Access Compliance Report

Public Rights-of-Way

(Curb Ramps)

Intersection ID: 15268	Main Street: CRESTRIDGE_DR	Cross Street: FIELDCREST_RD	Location: S
ADA ID: 56535B3D8C20	Ramp Type: PerpDiag	Initial Pass/Fail: Fail	Overall Compliance: No
Severity Score: 25			
Codes/Mitigation Info/Possible Solution		Field Measurements/Component Compliance

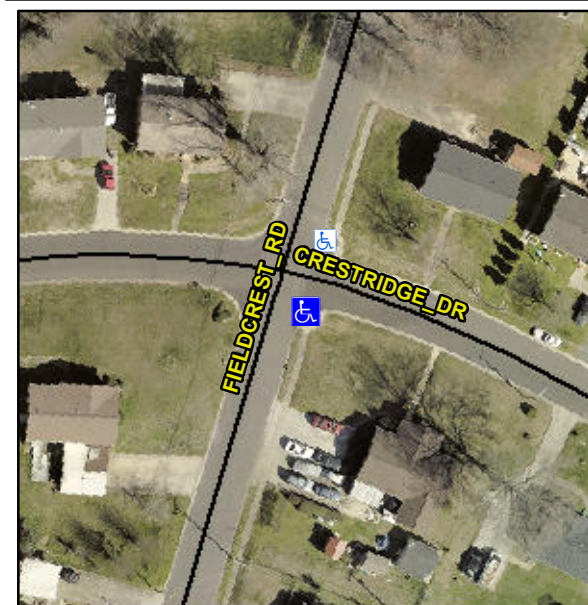
Not Found, R304.5.3

Compliance	Description	Data	Compliance	Description	Data
N/A	Ramp Length (in)	66.0	Yes	Ramp Slope (%)	7.4
Yes	Ramp Width (in)	48.0	No	Ramp XSlope (%)	9.5
N/A	Flare Type LT	N/A	N/A	Flare Type RT	N/A
N/A	Flare Slope LT (%)	N/A	N/A	Flare Slope RT (%)	N/A
N/A	Flare Traversable LT?	N/A	N/A	Flare Traversable RT?	N/A
N/A	Landing Length (in)	N/A	N/A	DWS Provided?	N/A
N/A	Landing Width (in)	N/A	N/A	DWS Contrast?	N/A
N/A	Landing Slope (%)	N/A	N/A	DWS Length (in)	N/A
N/A	Landing X Slope (%)	N/A	N/A	DWS Full Width?	N/A
N/A	Landing Curb? (Y/N)	N/A	N/A	DWS Offset (in)	N/A
N/A	Shared Landing?	N/A			
N/A	Gutter Ponding?	N/A	N/A	Gutter Slope (%)	N/A
N/A	Gutter Lip Ht (in)	N/A	N/A	Gutter X Slope (%)	N/A
N/A	Painted X Walk1?	No	N/A	Painted X Walk2?	No
	X Walk 1 Direction	To NE		X Walk 2 Direction	To W
N/A	X Walk 1 Width (in)	N/A	N/A	X Walk 2 Width (in)	N/A
	X Walk 1 Slope (%)	0.1		X Walk 2 Slope (%)	2.9
	X Walk 1 X Slope (%)	4.5		X Walk 2 X Slope (%)	3.1

Remove & Replace Curb Ramp With Two New Directional Ramps or Equivalent.
